# FINAL DEVELOPMENT PLAN

## LOT 4 MOB

RE: Buckles Court (Lot 4) MOB Final Development Plan

## PLANNING COMMISSION STAFF REPORT

DRAWING NO.:  
**C200**

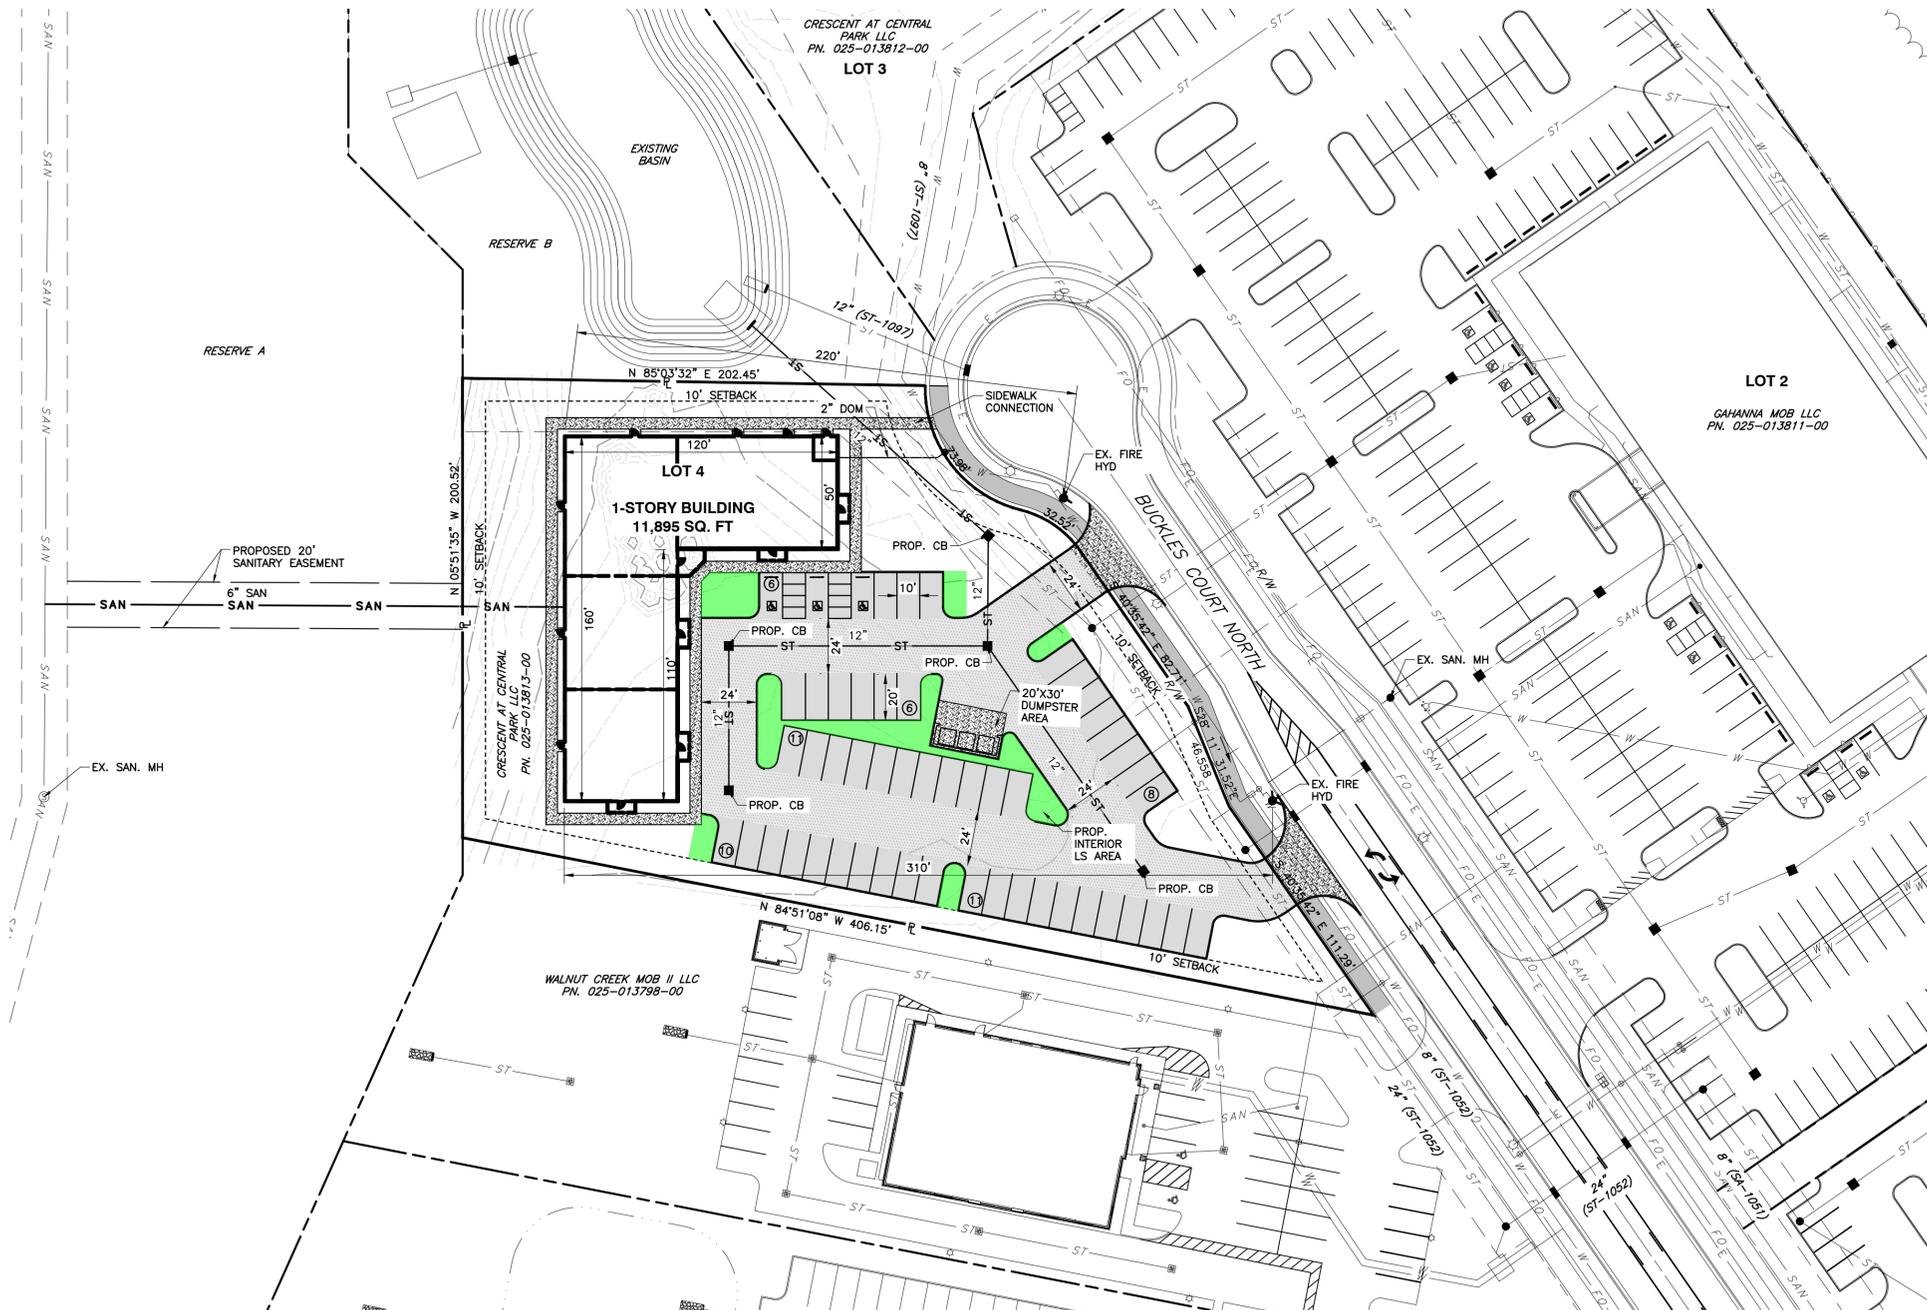
7. I can see that space appears to be limited for the one tree per 100 square feet for interior landscaping requirement. However, I believe more trees can be planted than are included on the plans. I'd like to see an effort to include more trees especially since many trees are proposed to come down as part of this project.

8. Add a legend describing existing and proposed utilities.

9. Consider relocating the dumpster to not conflict with the proposed storm utility.

12. An easement will be required for the 6" sanitary sewer lateral through "Reserve A".

Additional trees added to the plan.

A legend has been added to the FDP.

Storm sewer rerouted to avoid dumpster.

OK as noted. Proposed easement shown on plan.
